Re: Scenic View Drive Pump Station (PR#156-2022)
Rockaway Beach Water District (PWS ID# [00708](#))
Final Approval

Final Approval – PR #156-2022

Re: Scenic View Drive Pump Station (PR#156-2022)
City of Rockaway Beach (PWS ID#00708)
Final Approval

Response to Conditions of Approval

RECORD DRAWING 11/27/2023

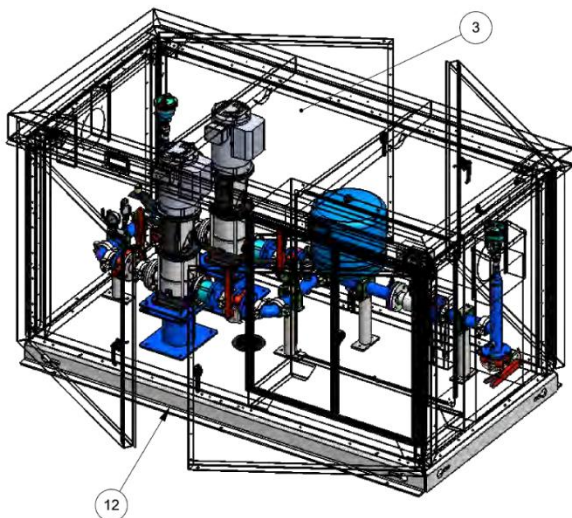
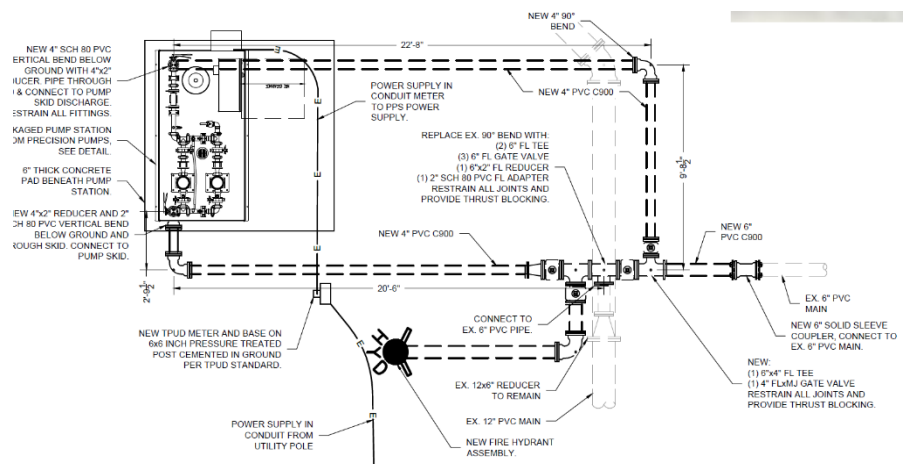
- C *As the pump station draws water from a water main, should suction pressures be less than 20 psi in the supplying water main upon construction, an explanation as to the severity of the low-pressure conditions and plans to mitigate low pressure in the main shall be submitted prior to Final Approval.*

- R The pump station was installed with a low-pressure cutoff switch identified by item 6 on sheet C-6. The low-pressure cutoff switch was set to be 17 psi as measured at the pump station. The water main in this location is approximately 10 ft deep. A low-pressure cutoff point of 17 psi would shut the pump station down when the main pressure drops below 21 psi. The low-pressure cutoff switch is adjustable by City personnel.
